Re: Cost Change Proposal Number 3, 57831683-22 Cathodic Protection Program FY22

Change of Contract Price Proposal No.3

Cathodic Protection Program FY22

Fig 1: Benching Requirements per OSHA 1926 Subpart p App B Sloping and Benching, Excavations made in Type B Soil

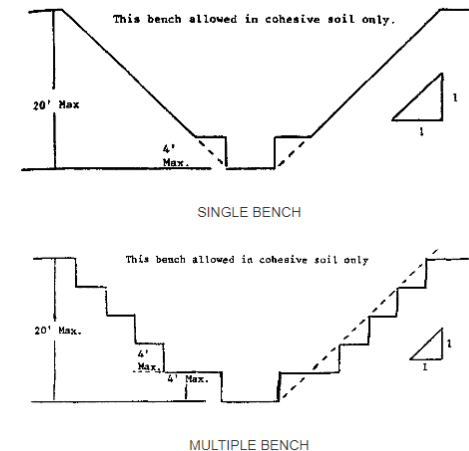
Requirements for benching size and spacing are determined by soil type; these excavations have been in type B soils, requiring a 1:1 height to width ratio (*Figure 1*).

Figure 2: Soil Volumes Removed at Depth

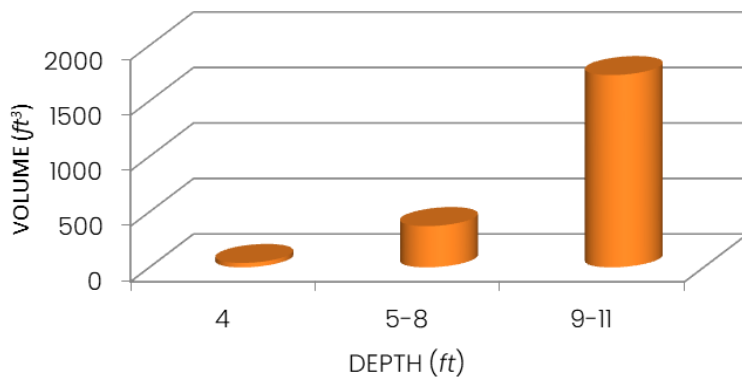
To meet OSHA standard 1926 Subpart P, benching has been utilized to safely excavate water main exceeding five feet in depth. An excavation at 5-8ft requires moving more than 9 times more dirt than an excavation at 4ft (*Figure 2*). This has continued to quadruple labor hours to install a single galvanic anode (*Figure 3*).

Figure 3: Hours Required in Relation to Pipe Depth

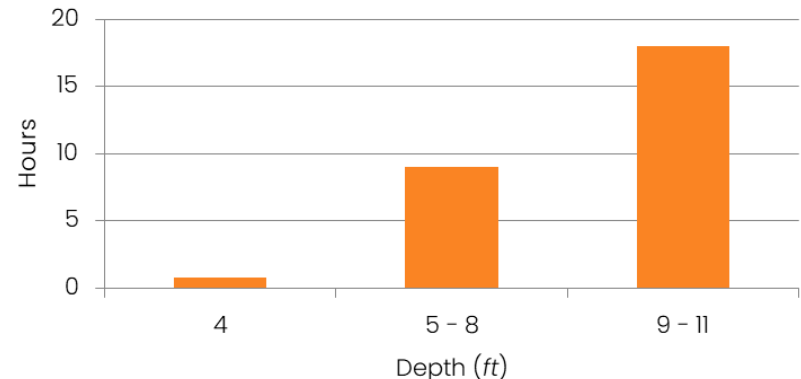
Labor times are significantly increased when excavating deeper than 5ft to meet OSHA requirements. When the pipe is at a 4ft depth, total installation times have taken approximately one hour; depths exceeding 6ft have more than quadrupled installation time, and once depths exceed 8ft, an additional laborer has been necessary to assist with tools and safety.

Figure 4: Surface Area Impact Visualization

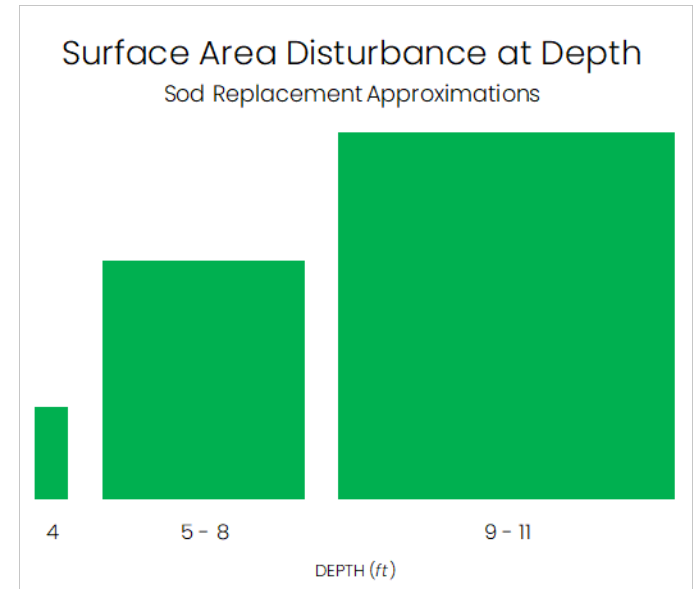
With increased depths, the size of the impacted surface increases considerably. A single pallet of sod typically covers more than 35 excavations of four feet; whereas, that entire pallet of sod is needed to complete a single excavation of nine feet or deeper (*Figure 4*). A recent clean-up of a seven foot excavation required an entire pallet of sod and 12 labor hours to complete; this site has required over 1,500 gallons of water and four labor hours weekly to maintain.
